Re: Petition of VCP EPC, LLC for Declaratory Ruling for the Construction, Operation, and Maintenance of a 2.99 MW AC Roof-Mounted Solar Photovoltaic Electric Generating Facility at Dollar Tree Distribution Center, 99 International Drive, Windsor, Connecticut

**Petition No. 1507
VCP EPC, LLC d/b/a Verogy
99 International Drive, Windsor
Interrogatories**

SECTION "A-A"

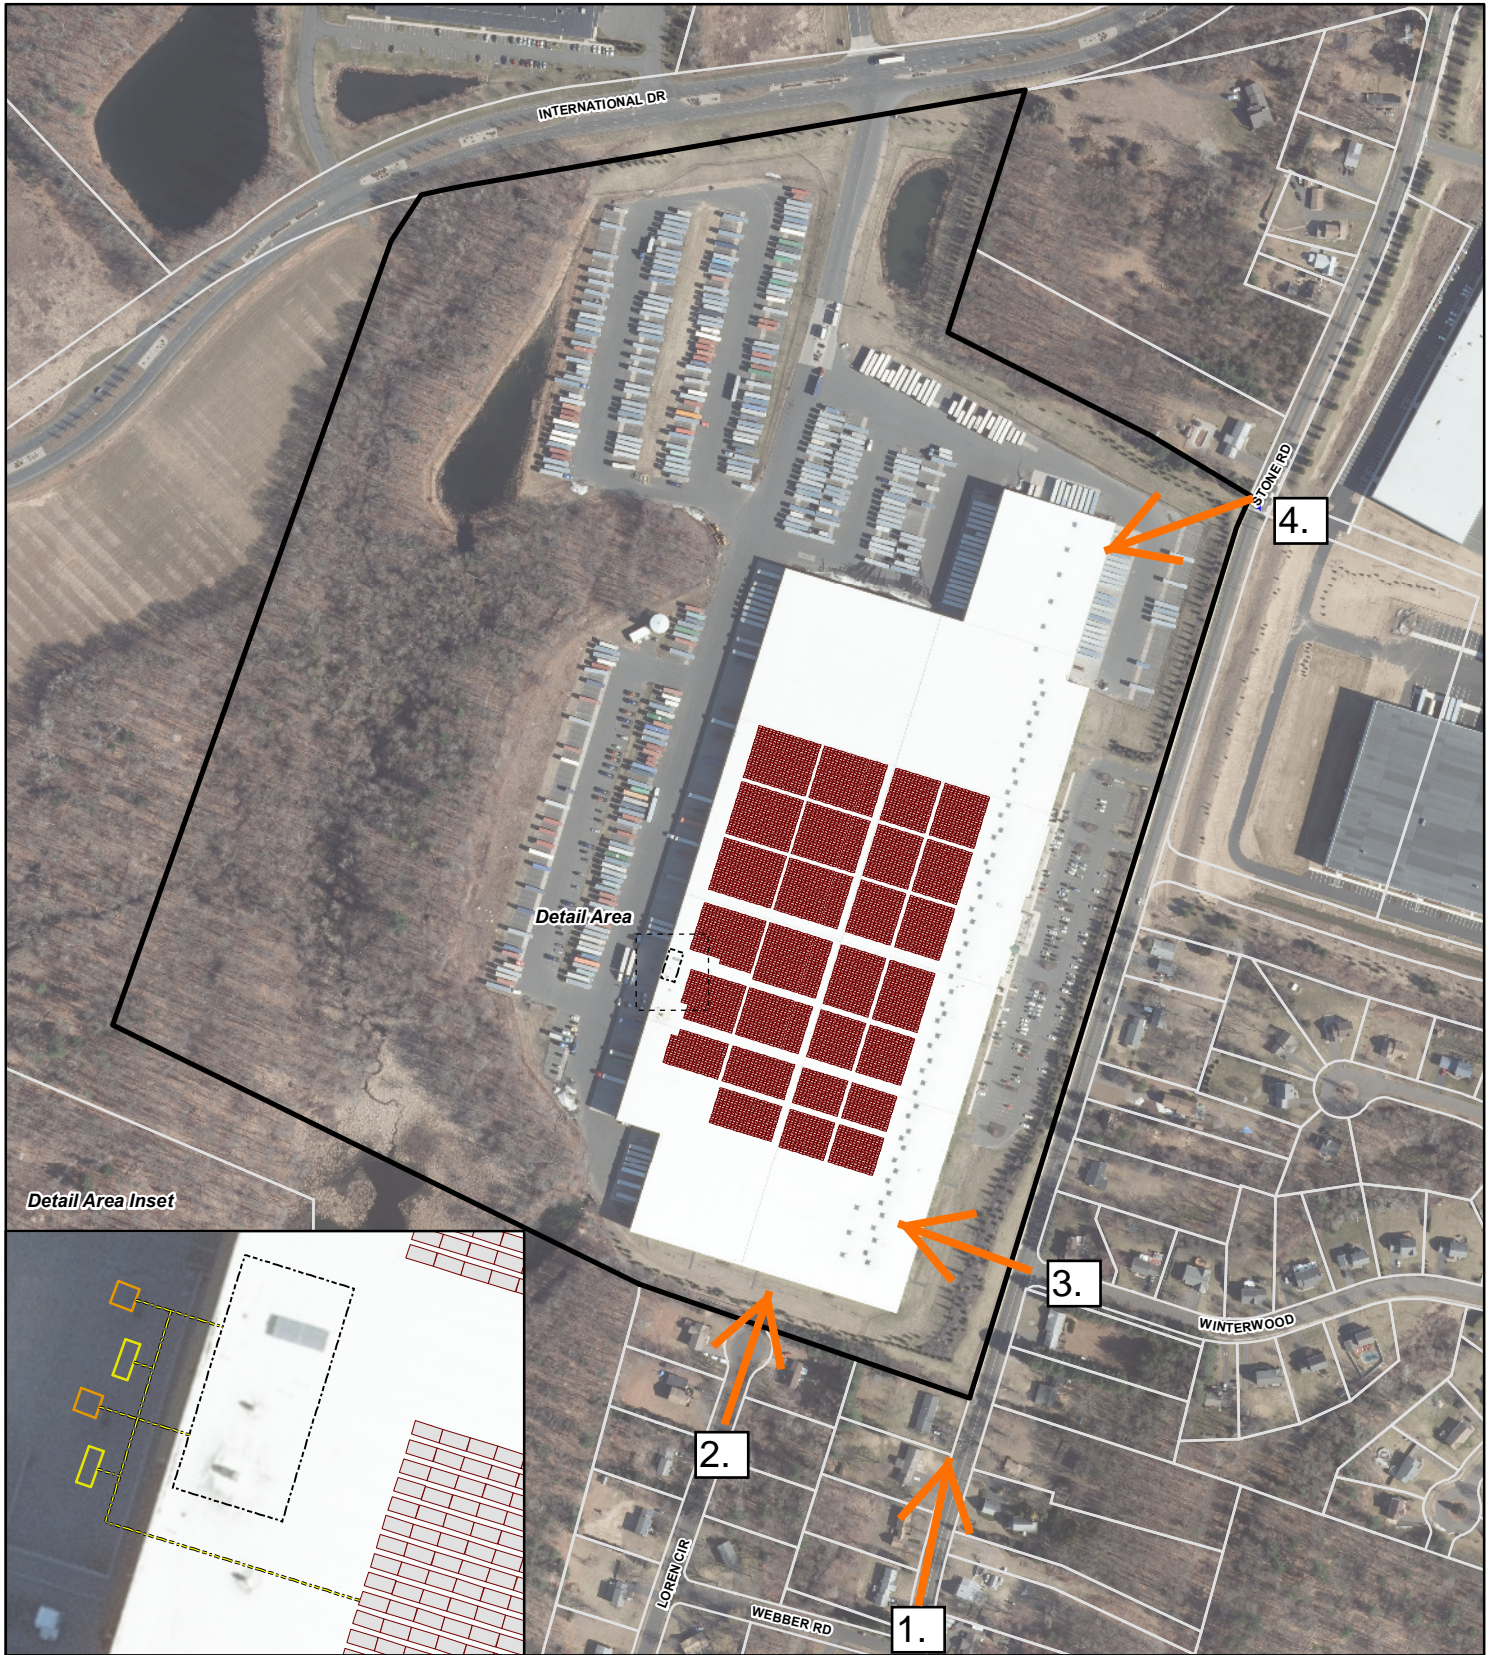
12. Provide a side profile drawing to depict the solar panel angle with the horizontal, and the maximum and minimum heights of the arrays above the roofline. How high is the roof in feet above grade?

See Exhibit 1 for a side profile drawing showing the solar panel angle above the roofline. The panels are in landscape orientation facing south at a 10 degree tilt and are 13.48 inches above the roof at their highest point. The roof is approximately 43 feet high on the western and eastern sides and 50' high in the center.
